INSTALLATION BULLETIN 106

Revision 2
July 18, 2005

Subject: This revision to IB-106 describes the wiring changes for proper integration of the Flight Director Command Bar presentation to the Chelton EFIS and AIU from the Sperry SPZ-200/500 Flight Director Computer. Scaling Factors for the AIU Flight Director Horizontal and Vertical detectors are increased as shown in the table.

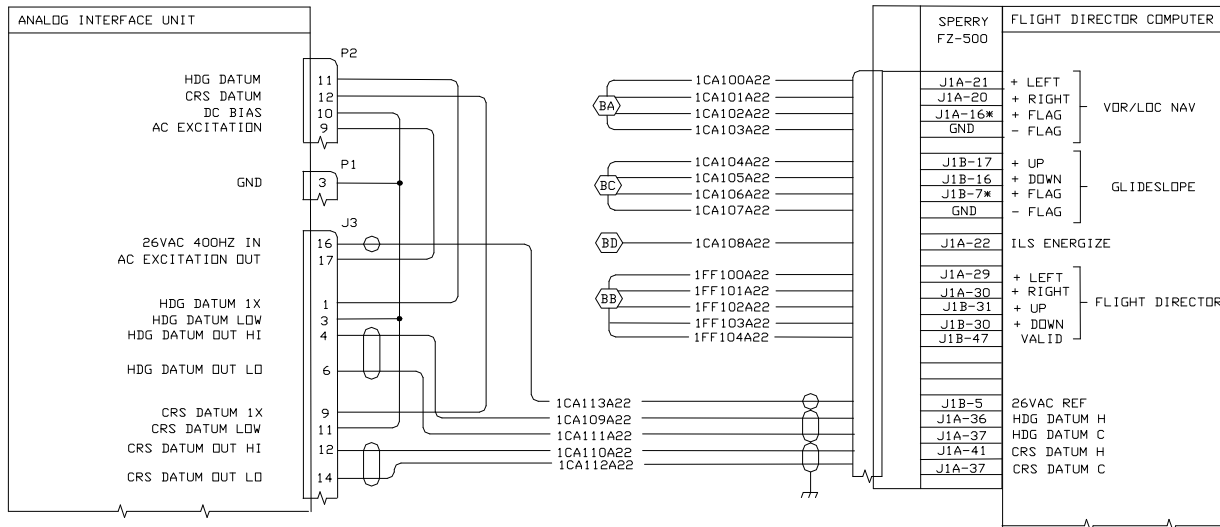
Correct AIU configuration is as follows:

The AIU to Honeywell-Sperry SPZ-200/500 interface wiring should be as follows:

*NOTE: FLAG INPUTS TO AUTOPILOT MUST BE ROUTED THROUGH A BENDIX/KING KDA-688 SUPER FLAG CONVERTER OR EQUIVALENT.

NOTE: The Sperry Flight Director Computer (FZ-500) must be strapped for a 5-inch indicator drive. If the Flight Director Computer strapped for a 4-inch indicator drive, perform the following steps.

- (1) Remove the wire from FZ-500, J1A, Pin 61 and insert into J1A, Pin 60 for the Roll Command bar. This will make a jumper between J1A, Pin 62 and J1A, Pin 60.
- (2) Remove the wire from FZ-500, J1B, Pin 12 and insert into J1B, Pin 11 for the Pitch Command bar. This will make a jumper between J1B, Pin 13 and J1B, Pin 11.
- (3) Adjust the Horizontal and Vertical Flight Director Scaling in the AIU Maintenance program as described in Chapter 5 of the AIU Installation Manual (Doc. 570-7000).
